## **DONLONS SUBDIVISION**

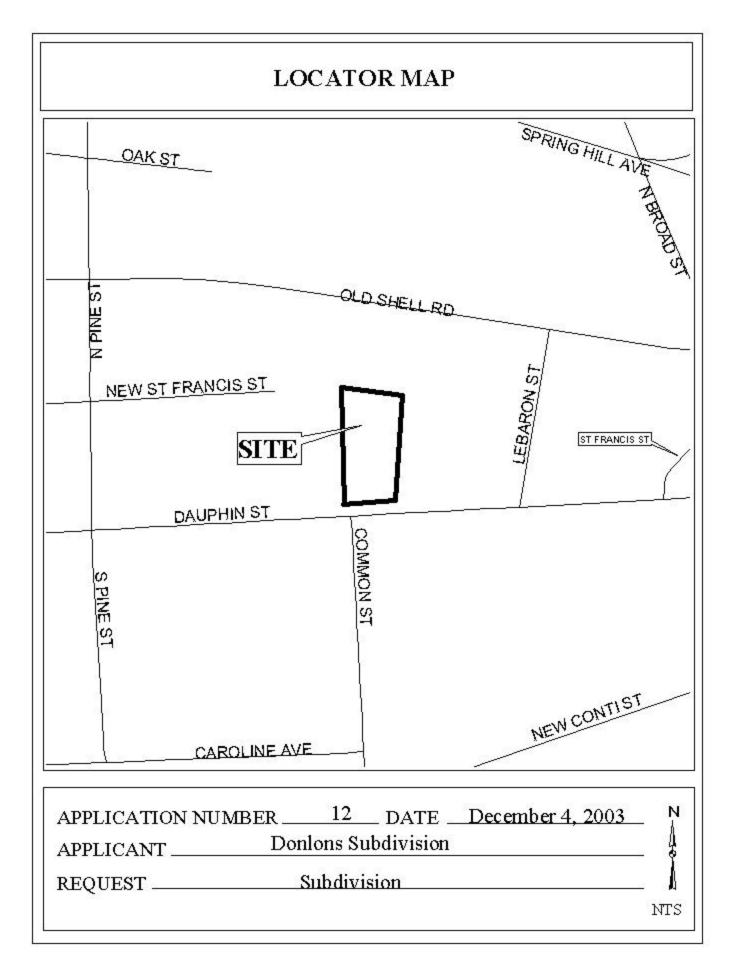
The plat illustrates the proposed 2 lot,  $0.5 \pm \text{acre}$  subdivision which is located on the North side of Dauphin Street, 280'  $\pm \text{West}$  of Lebarron Street. The subdivision is served by public water and sanitary sewer.

The purpose of this application is to subdivide a metes and bounds parcel into two lots.

The site fronts Dauphin Street, a planned major street, and the existing right-of-way is shown as 60 feet, along Dauphin Street, the provision of an additional setback (45-feet) should be provided. This would prohibit any new additions within the future Major Street right-of-way. Additionally, the placement of a note on the final plat stating that any new curb cuts must be approved by Traffic Engineering, should be required.

As proposed, Lot 1 would exceed the width to depth ratio, therefore a waiver of Section V.D.3. would be required.

With modifications and a waiver of Section V.D.3., the plat meets the minimum requirements of the Subdivision Regulations and is recommended for Tentative Approval subject to the following conditions: 1) the provision of a 45-foot setback line along Dauphin Street (this would apply to new additions); and 2) the placement of a note on the final plat stating that any new curb cuts must be approved by Traffic.
